AMENDMENT OF SOLICITA	1. CONTRACT ID CODE	PAGE	OF PAGES		
AMENDMENT OF SOLICITA	J	1	5		
2. AMENDMENT/MODIFICATION NO.	7/MODIFICATION NO. 3. EFFECTIVE DATE 4. REQUISITION/PURCHASE REC				olicable)
0003	11-Jun-2002	W16ROE-2114-9736

Amendment No. 3

AMENDMENT NO. 3 TO SPECIFICATIONS FOR REVITALIZE BARRACKS USMA PREPARATORY SCHOOL BUILDINGS 1204 & 1205, FORT MONMOUTH, EATONTOWN, NEW JERSEY

DETAIL - MOTORIZED DAMPER INTERLOCK CONTROL SCHEMATIC

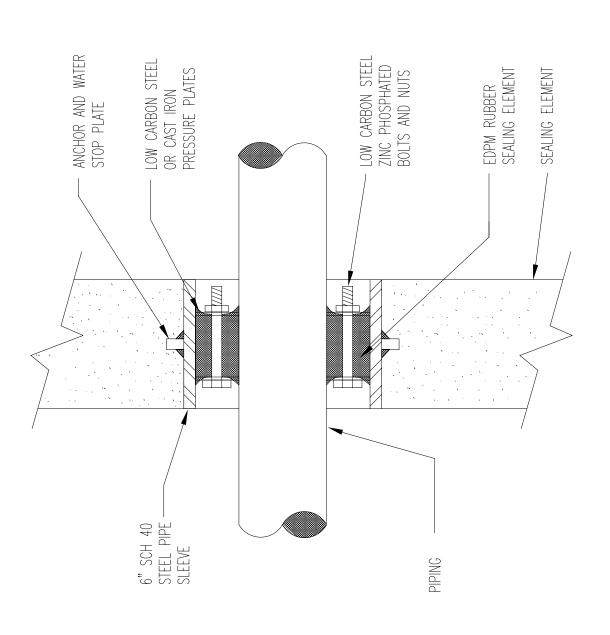
- a. Replace electrical schematic for dryer operation with revised sketch.
- b. Included in this amendment is a sketch for pipe penetration detail.

SCHEMATIC DIAGRAM FOR INTERLOCK CONNECTION BETWEEN LAUNDRY DRYERS AND MOTORIZED DAMPERS. TYPICAL FOR EACH PERSONAL LAUNDRY ROOM (EXCEPT UNIFORM LAUNDRY)

- 1. MOTORIZED DAMPER ACTUATOR MAY OPERATE IN 24V. ENSURE STEP-DOWN TRANSFORMER ARE PROVIDED FOR ACTUATOR OPERATING VOLTAGE, IF ONE IS NOT SUPPLIED BY ACTUATOR MANUFACTURER.
